MILITARY SPECIFICATION
SWITCH, HYDROSTATIC, MARK 63 MOD 0 AND MOD 1

This amendment forms a part of Military Specification MIL-S-23772 (Wep), dated 25 June 1963, and has been approved by the Naval Ordnance Systems Command, Department of the Navy.

FIGURE 1

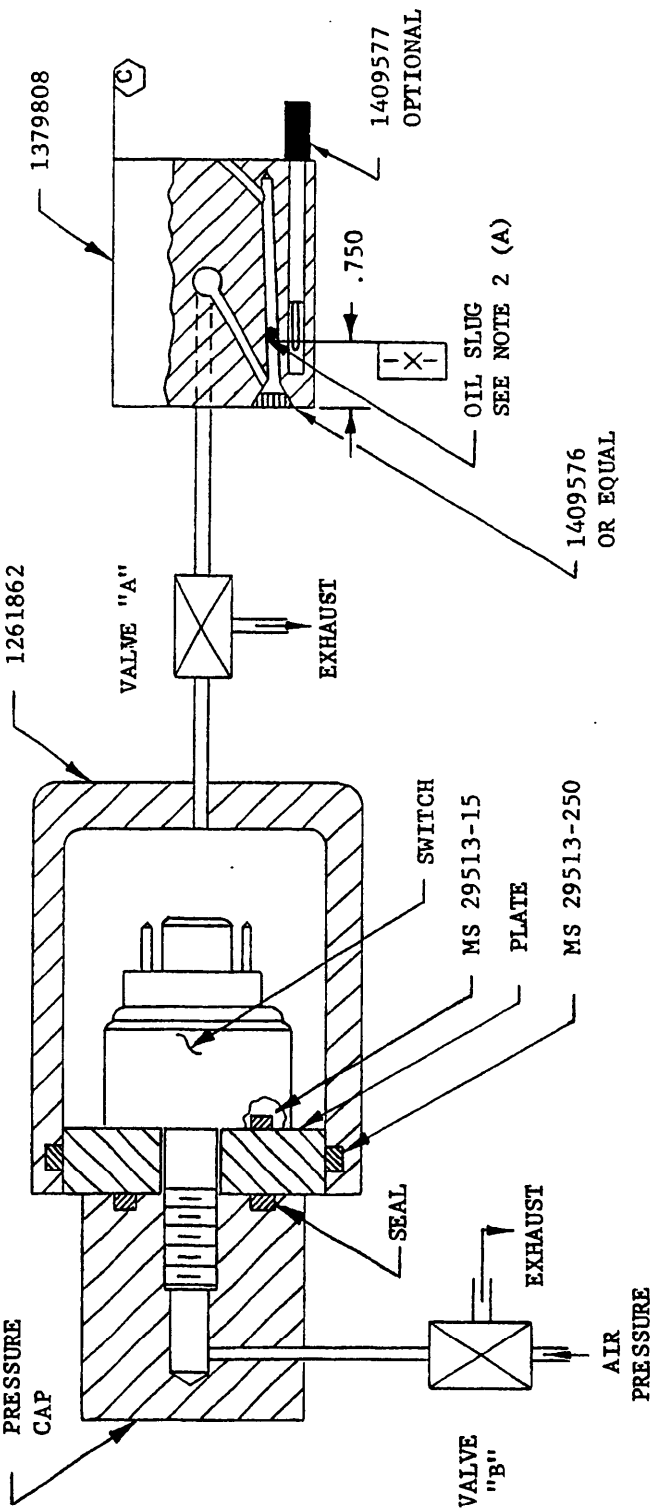
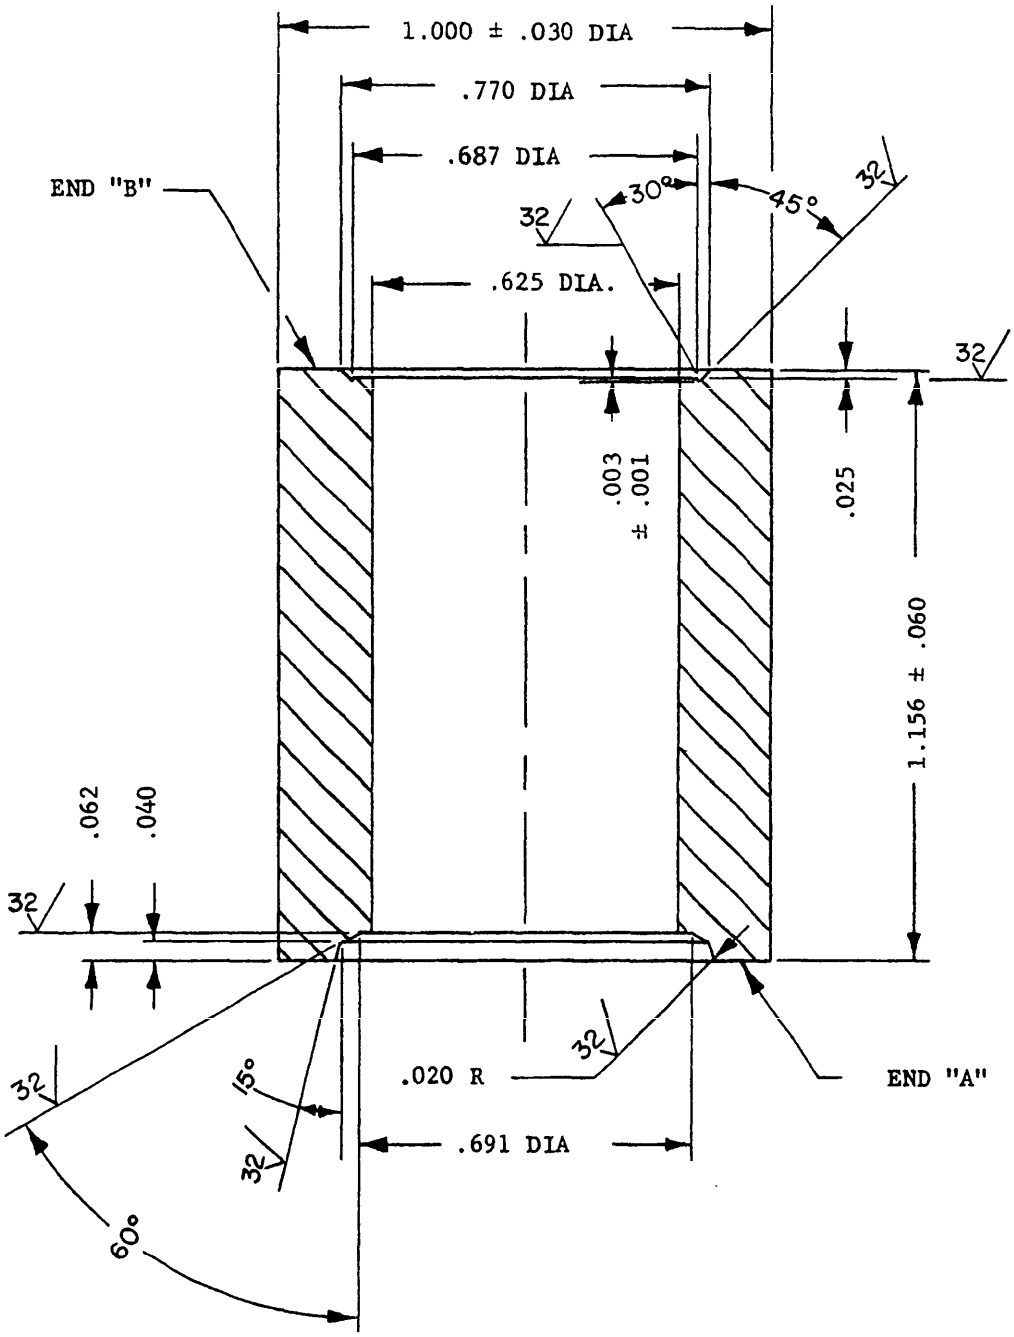
* Pages 15 and 16, delete Figures 1 and 2 and substitute the attached sheets.

NOTES:

1. ENTIRE LEAK TEST APPARATUS OF THIS FIGURE SHALL WITHSTAND WITHOUT LEAKAGE 5 PSIG AIR PRESSURE FOR 2 TO 5 MINUTES.
2. (A) TO USE THIS LEAK TEST APPARATUS, OIL SLUG SHALL BE 3 DROPS OF MINERAL OIL, VISCOSITY 20-30 CENTISTOKES @ 25°C, COLORED WITH RED OIL SOLUBLE DYE. (B) SURFACE Ⓒ OF MANOMETER SHALL BE MAINTAINED IN LEVEL POSITION DURING TEST. (C) DURING TEST, TRAILING EDGE OF OIL SLUG SHALL MOVE BEYOND DATUN [-X-] BEFORE TIMING IS BEGUN. (D) MANOMETER VALVE "A" SHALL BE FULLY OPENED TO ATMOSPHERE UNTIL TEST PRESSURE ON PRESSURE SIDE OF SWITCH HAS BEEN ATTAINED, AND FULLY CLOSED TO ATMOSPHERE BEFORE TIMING OF OIL SLUG BEGINS.
